**RE: Peer Review of Dobroyd and Hawthorne Canal Flood Studies: Summation**

**RE: Peer Review of Dobroyd and Hawthorne Canal Flood Studies**

**Re: Response to Letter "Peer Review of Dobroyd and Hawthorne Canal Flood Studies"  
dated 25 May 2016**

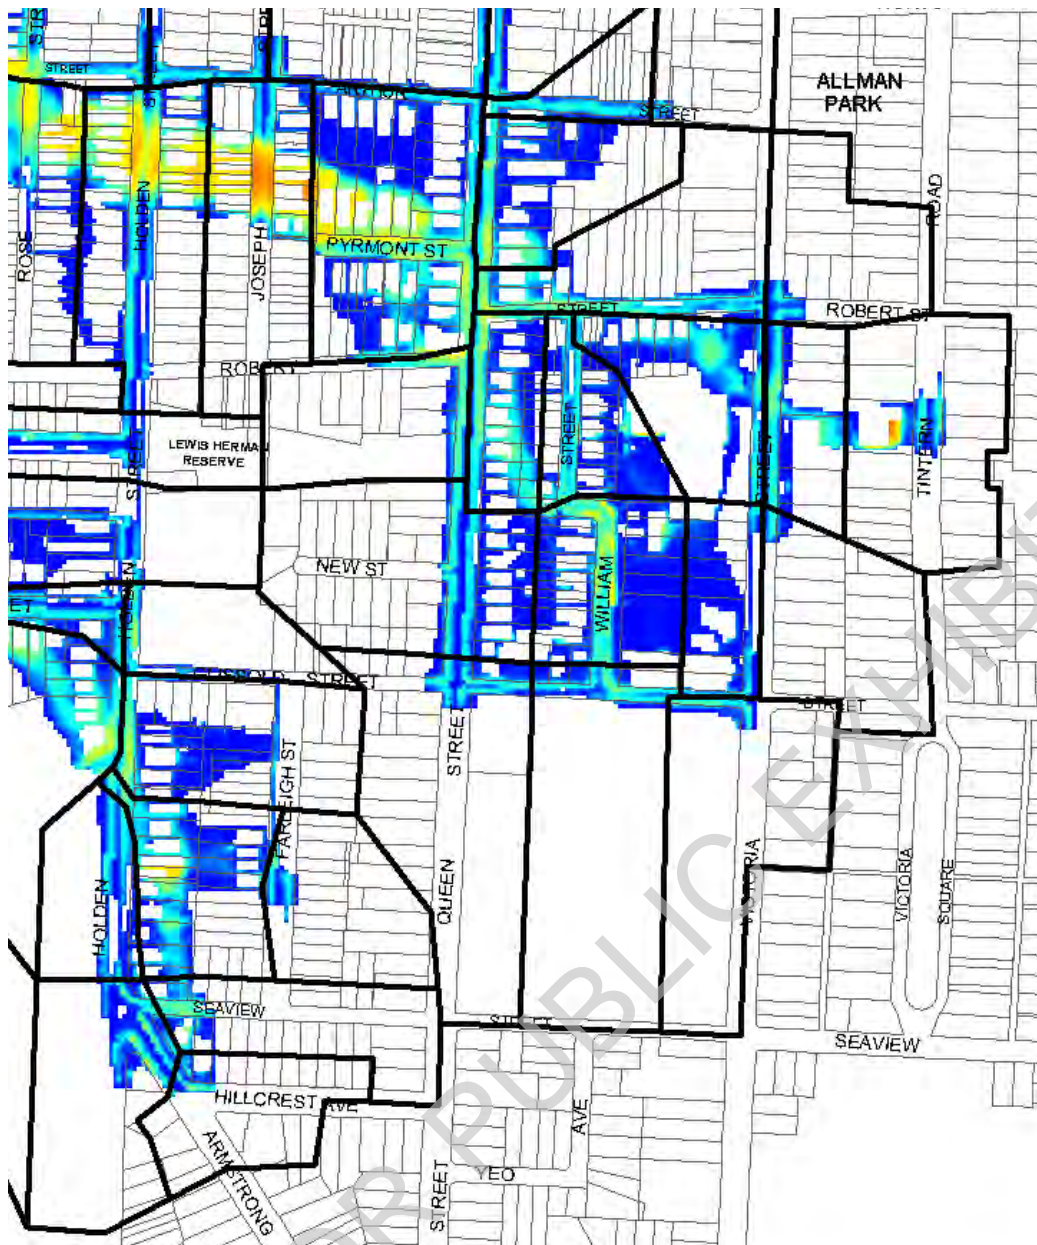
- a) ALS/Lidar for model DEM;
  - b) Pit and pipe data;
  - c) Rainfall;
- ii. Overall model approach / model development. While I understand the broad modelling approach of combining a DRAINS model of the upper catchment, primarily for generating catchment runoff, and a TUFLOW model to represent the floodplain flow paths, it's not clear to me from the report how the two models interface and which catchment/floodplain elements are included in each model. Please clearly describe how the models interface i.e. which catchment/floodplain components are in the DRAINS model and which are in the TUFLOW model, and how they connect to each other in the model. Please specifically describe how the components of the pit and pipe stormwater system interface with the catchment runoff hydrographs and surface water flow paths. A conceptual model diagram(s) might assist in this regard;

DRAINS was used for the hydrologic model for the conversion of rainfall into flow. The catchment/floodplain elements included in the DRAINS model were: sub-catchment area, sub-catchment slope, impervious percentage, and rainfall losses. No routing of flows between sub-catchments was undertaken in DRAINS (instead this was undertaken in the TUFLOW hydraulic model), and hence no pipe dimensions or overland flow path dimensions were defined in the DRAINS model.

The flows from each individual sub-catchment from the DRAINS model were input into the 2D TUFLOW hydraulic model as point inflows. These point inflows were located at the downstream boundary to each sub-catchment and corresponded to the kerb and gutter system. This emulates the way most properties are designed to drain intralot flow and roof flow into the street gutters.

Within TUFLOW, flow applied to the gutter system (modelled in the 2D domain) travels based on elevation and roughness (Manning's value) and enters the pit and pipe system (modelled in the 1D domain) via 1D-2D connections.

Diagram 1: Extract from Australian Rainfall and Runoff (1987)

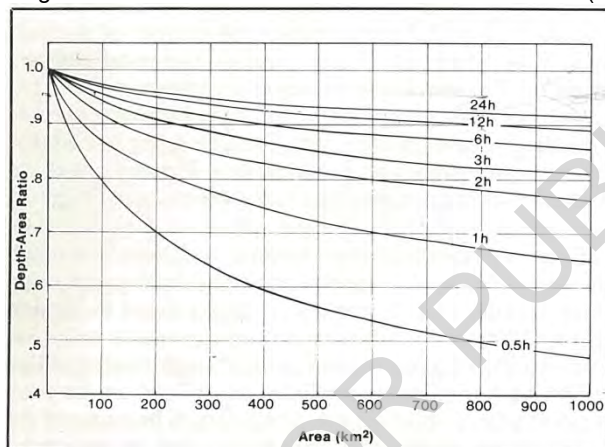
- ix. **Section 2.8 Design Rainfall Data** – were catchment reduction factors applied? If not, why not?
- x. **Section 4 Hydrologic Model, 4.1 Sub catchment definition.** There are many sub-catchments. How was the catchment boundary and outlet location of each sub-catchment defined? E.g. area contributing to a stormwater pit?

Aerial reduction factors (as per Australian Rainfall and Runoff 1987 (AR&R 1987)) predominantly affect large catchment areas, as shown in Diagram 1 extracted from AR&R 1987. The Dobroyd Canal and Hawthorne Canal catchment areas were less than 10 km<sup>2</sup>, and as such the Depth-Area Ratio was converging on 1 (from Diagram 1). Therefore, no catchment reduction factors were applied to the design rainfall data.

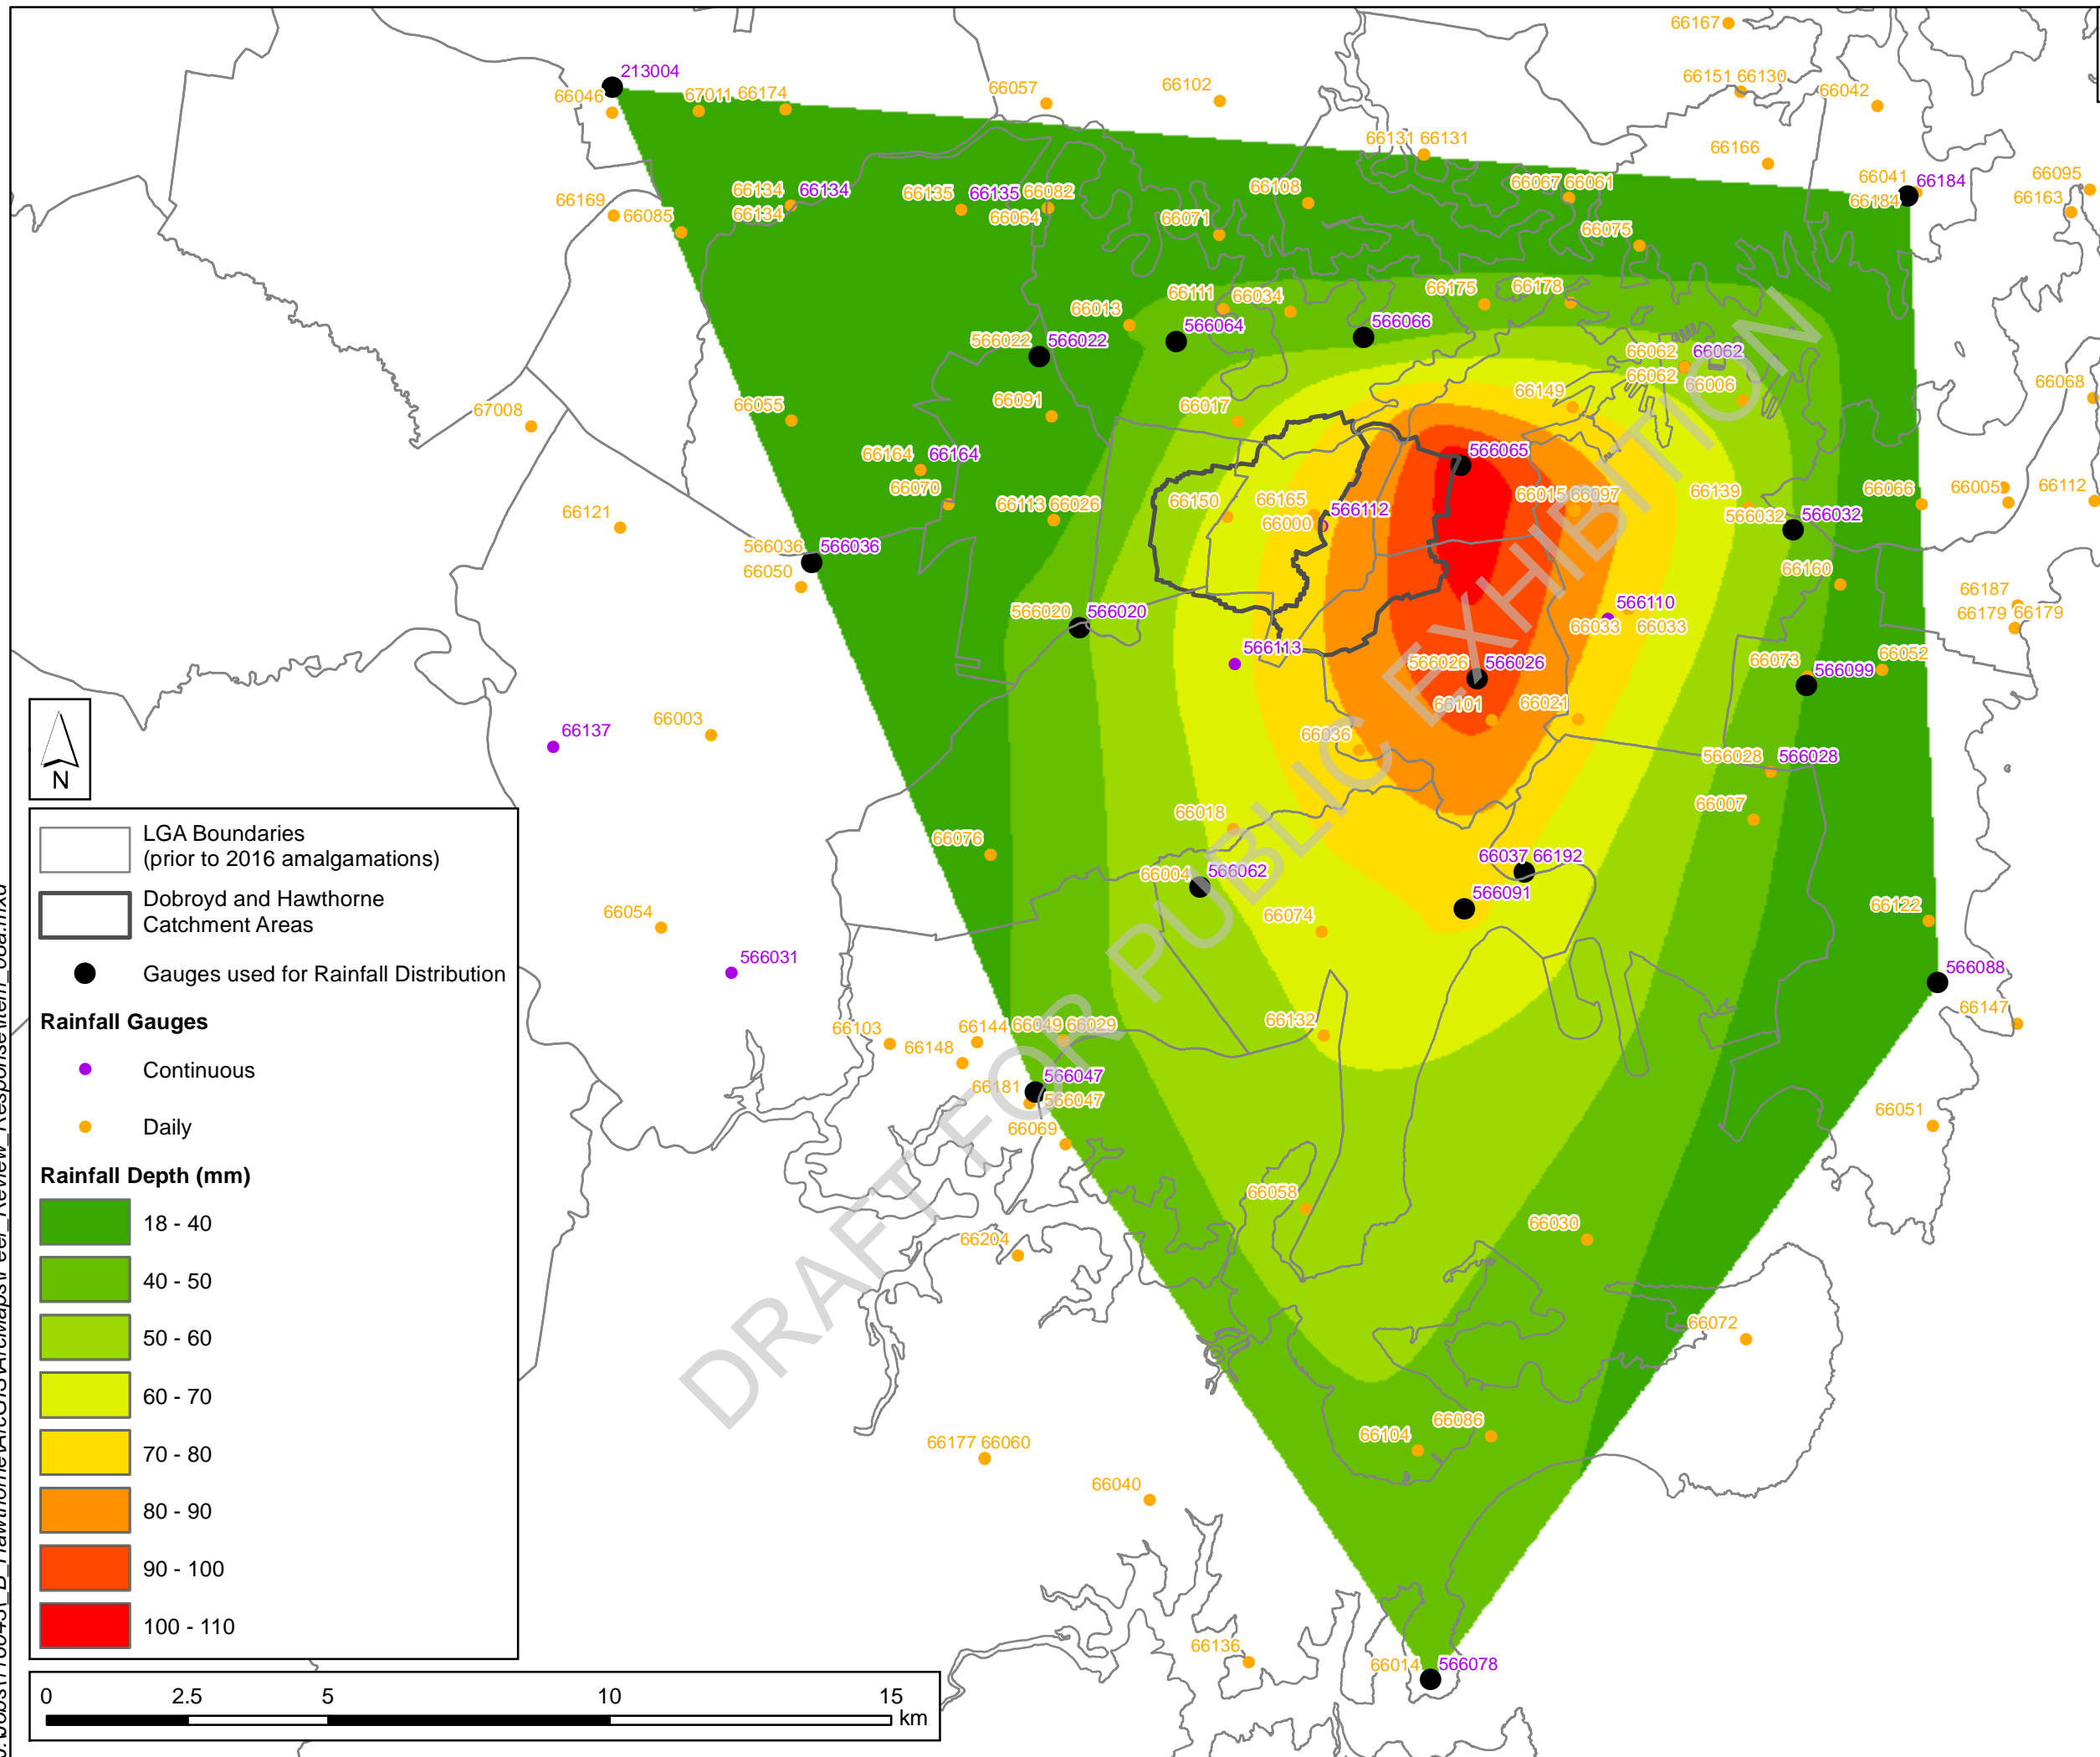
- xvi. Council has noted several locations where either the Council or the local community has concern with the model results. Could you please name these locations, summarise the Council/community concerns, and for each floodplain location provide a detailed description of the model configuration, model calibration/validation results and design model results.

Community concerns were less centred on specific locations and were more centred on the whole model process. The Railway Embankment over Dobroyd Canal and the Parramatta Road Bridge over Hawthorne Canal is representative of the hydraulic model configuration across the catchments. At these locations, the open channel is represented as a 1D element, carved into the 2D domain. This is shown in the attached figures.

J:\Jobs\116043\B\_Hawthorne\ArcGIS\ArcMaps\Peer\_Review\_Response\Item\_08a.mxd

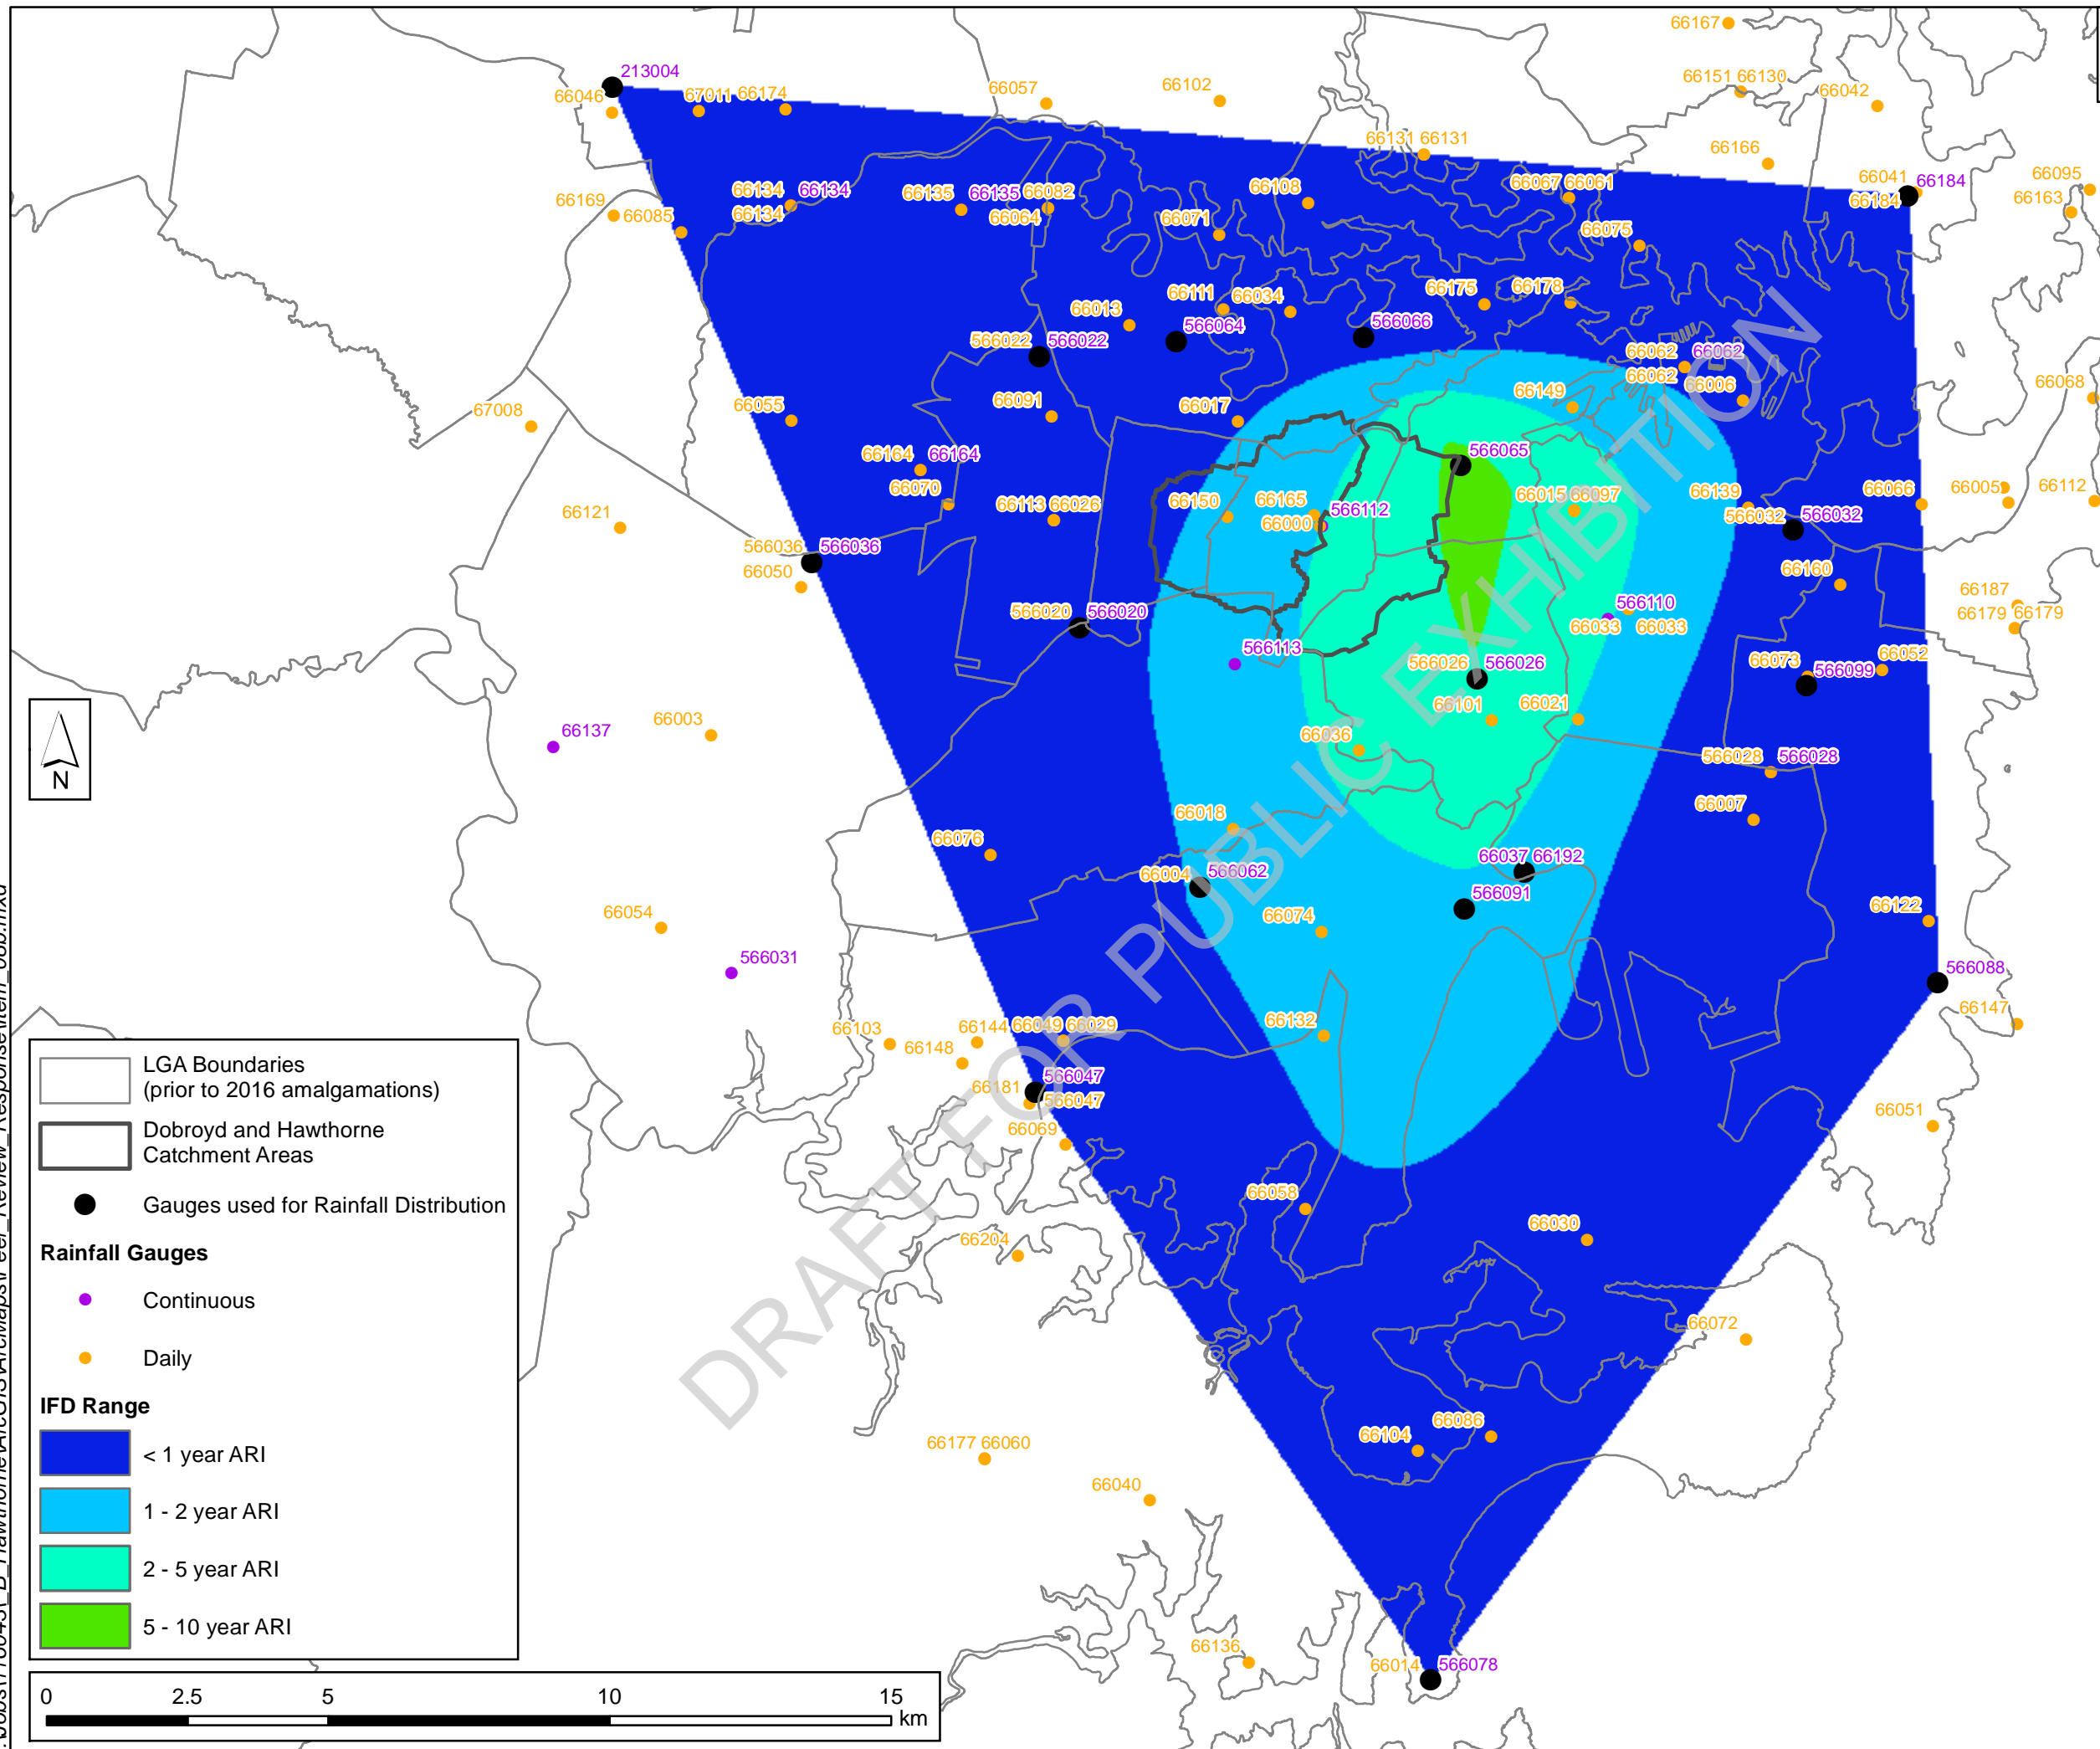
- viii. **Section 2.7 Historic Rainfall Data.** Further information on the spatial variability of rainfall would assist in the interpretation of the model calibration outcomes. Suggest that a graphical representation of rainfall e.g. rainfall isohyets for historical events in the local area, and perhaps also in the wider Sydney area compared to design rainfalls would help put the model calibration in better context;

The spatial distribution of the rainfall depths and IFD ranges is shown on “Item 8A” and “Item 8B” for the February 1993 6 hour storm burst and “Item 8C” and “Item 8D” for the March 2012 6 hour storm burst.
